Process Change Notification

Aug-1st-2015

Title: MCC Introduces Auto-Soldering Process For DB-1&SDB-1 Package

PCN#: 080115-2

Auto Soldering Process Part Identification:

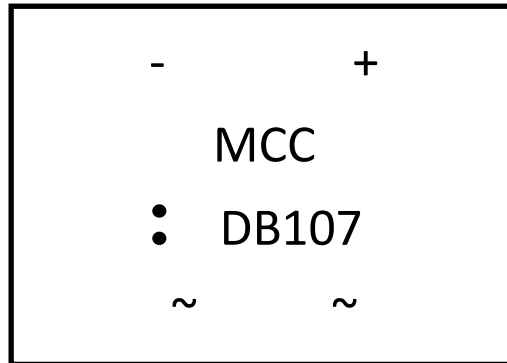
To enhance the efficiency and yield of soldering process, MCC added auto soldering line for DB-1 and SDB-1 packages, die size and outline will keep the same.

Internal qualification process had been finished and the result showed that the parts with new auto soldering process had the same performances as the parts we shipped before. To better track the parts with auto soldering process, MCC will add two dots on body for the parts with new process.

Devices with new process , identified with two dots on body ,see below for example:
